Appendix A – Design Changes Due to the Addition of the HI-STAR 190 Casks

AREVA Federal Services LLC		
	Engineering Information Record		
Document No.:	EIR-3016139	Rev. No.	001 Page 1 of 10
Project No.:	00225.03.0050	Project Name:	DOE Atlas Railcar
Title:	Atlas Railcar CLIN 4 Event 1 White Paper		
<p>Summary: This document provides a white paper detailing required changes to the DOE Atlas railcar conceptual cradle attachment components and Phase 1 conceptual cradle designs due to the addition of the HI-STAR 190 SL and XL casks to the project.</p> <p>This document is not safety related.</p>			
Safety <input type="checkbox"/> Non-Safety <input checked="" type="checkbox"/>			
Contains Unverified Input / Assumptions: Yes: <input type="checkbox"/> No: <input checked="" type="checkbox"/>			
	Printed Name	Signature	Date
Preparer:	Slade Klein		
Checker:	Alec Ross		
Approver:	Don Hillstrom Engineering Manager		
Other:	Mark Denton Project Manager

Title: Atlas Railcar CLIN 4 Event 1 White Paper

Project: 00225.03.0050 - DOE Atlas Railcar

Figure 3-1: Vertical Load from Longitudinal Transportation Loading

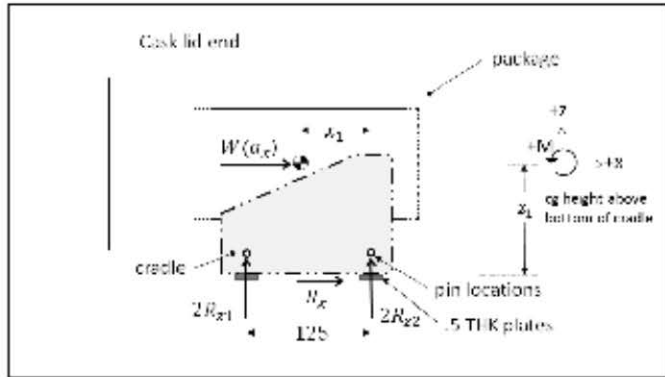
With the increased load due to the HI-STAR 190 XL weight, there was a concern that the attachment components center pin blocks would not be able to support the vertical and lateral transportation loads. The HI-STAR 190 XL loading configuration and vertical cg location were key in this evaluation. Holtec International confirmed that the cask could be positioned with the impact limiter at the minimum distance of 1 inch from the deck. (A 1 inch minimum clearance is required between the cask impact limiter and the railcar deck per Section 2.2.2.7 of [3]). This provided a vertical cask cg of half the cask impact limiter diameter plus 1 inch. Because of this low cg, even with the increased weight, the HI-STAR 190 XL was not bounding for the vertical load applied to the cradle attachment components. The bounding vertical load comes from the NAC MAGNATRAN cask, which although restrained in the longitudinal direction by the cradle attachment components shear block, applies a vertical load due to the longitudinal transportation load and the cask cg offset above the shear key (See the Figure 3-1 below). The HI-STAR 190 XL is restrained longitudinally by the end stops and the vertical transportation load (2g) is much smaller than the vertical reaction seen by the NAC MAGNATRAN due to the longitudinal transportation load (7.5 g).

The increased maximum weight from the HI-STAR 190 XL and revised loadings discussed above resulted in a reevaluation of the conceptual cradle attachment component design. The center four pin blocks were found to be acceptable as designed to support the increased lateral and vertical load. The outer pin blocks were moved outboard (see section “New Maximum Cask Length” below) and redesigned to combine the inboard and outboard outer pin blocks from separate blocks into a single piece as shown in Figure 3-3. This change increases strength and will provide an advantage in fabrication. The attachment pin material strength was also increased to accommodate the increased loadings.

Figure 3-2: Lateral Transportation Loading

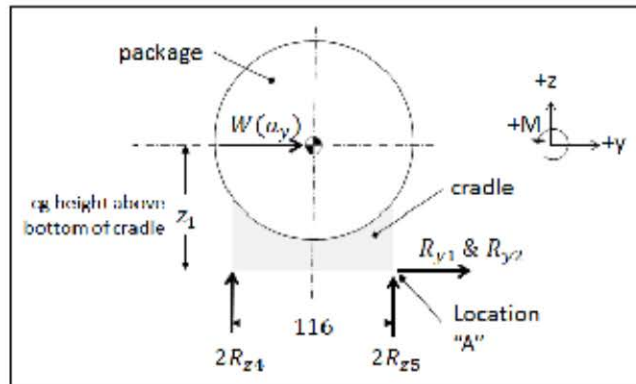
The HI-STAR 190 does provide a new bounding lateral load from the lateral transportation loading (which also applies a new bounding simultaneous vertical load). See the Figure 3-2 below.

Figure 3-3: Longitudinal Transportation Loading

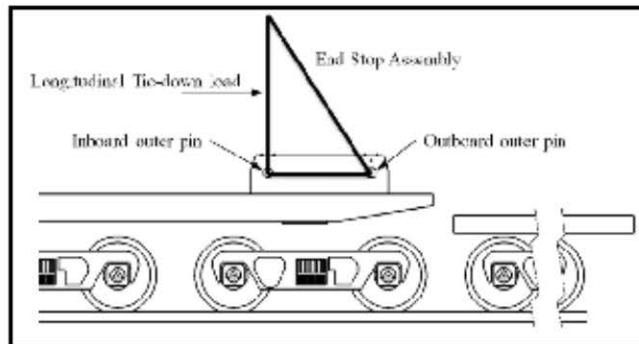
The HI-STAR 190 XL also provides an increased bounding load on the attachment components outer pin blocks due to the longitudinal transportation loading applied to the conceptual cradle end stops (see Figure 3-3 below).
